UNITED STATES PATENT AND TRADEMARK OFFICE

Advisory Action Before the Filing of an Appeal Brief	Application No. 10/807,592	Applicant(s) FRANKE ET AL.	
	Examiner Katherine W. Mitchell	Art Unit 3677

THE REPLY FILED 22 May 2006 FAILS TO PLACE THIS APPLICATION IN CONDITION FOR ALLOWANCE.

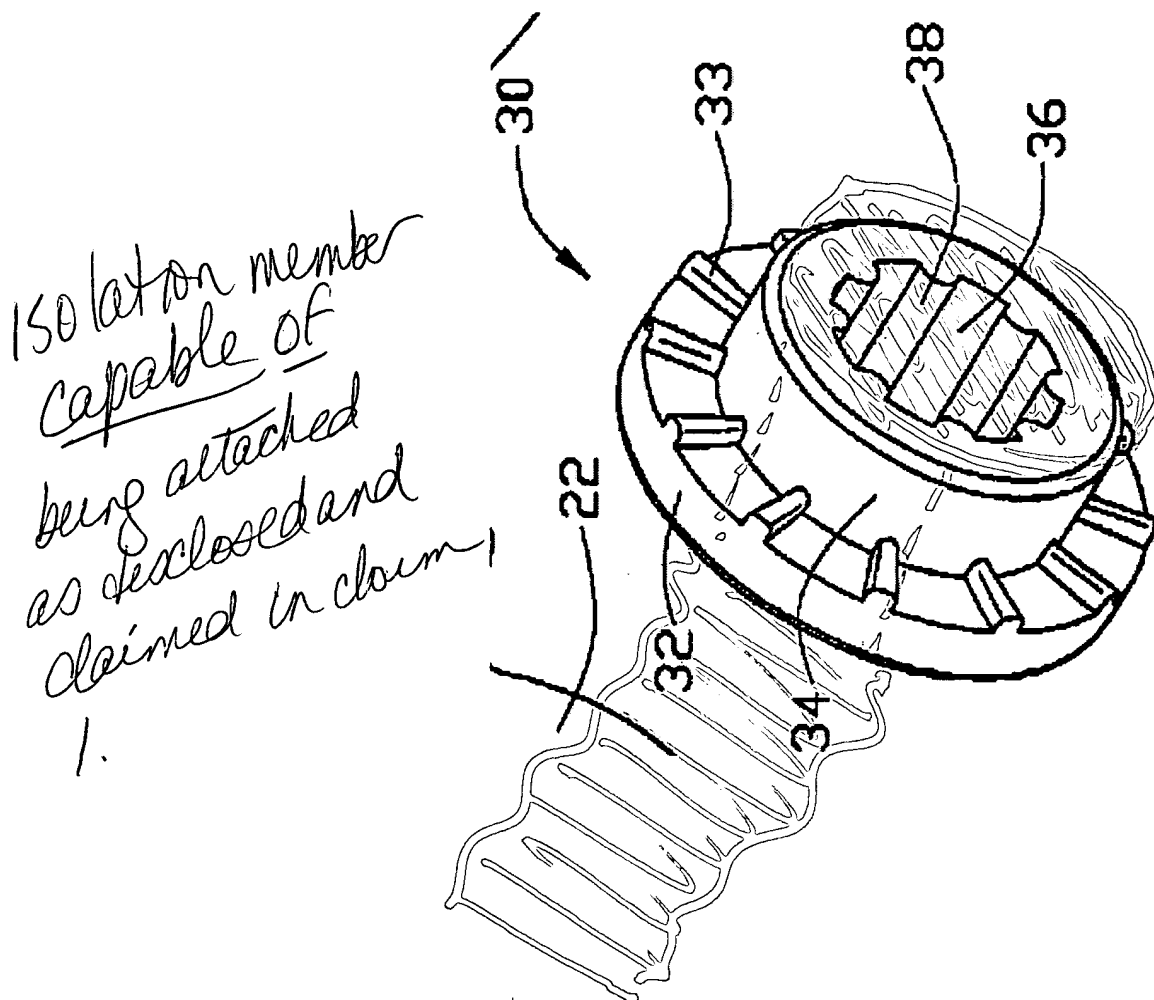
Continuation of 3: NOTE: Claim 20 was noted as allowable in that it included all the limitations of claim 19, which positively recites and requires a storage media drive with an outer housing that defines the end of the drive, and fasteners that ARE, not could be, mounted to the ends of the drive. This further limits what the drive cage and drive cage slot can be, as the drive housing must correlate to the drive itself. As noted in the previous action, claim 1 is specifically worded to claim only a fastener comprising an isolation member -- no structure of the drive, drive cage, fastener other than isolation member, are claimed or required. Note in particular Lin Fig 1 - isolation member 30 is CAPABLE of having a threaded shank with a head inserted as drawn below:
